Rezoning Transportation Analysis

Petition Number: #2021-120

General Location Identifier: 09503403

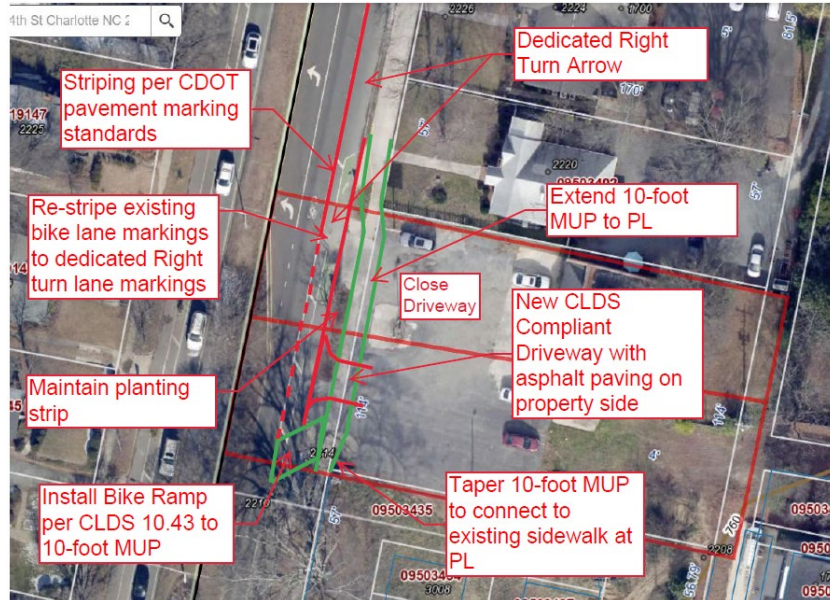
7. ~~Comment from 9-28-22:~~ Revise site plan and conditional note(s) to commit to remarking pavement markings and building a bike ramp near south property line to transition bicyclists from separated bike lanes to multi-use path.

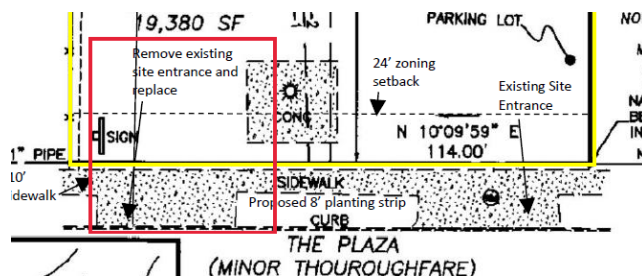
Outstanding Comment 10-26-22: After further coordination the above design has been updated as follows to. ~~Revise site plan and conditional note(s) to commit to remarking current bike lane pavement markings to a dedicated right turn lane, a bike ramp near south property line per CLDSM 10.43 to transition bicyclists from separated bike lanes to multi-use path and extending the 10-foot multi-use path to the southern property.~~
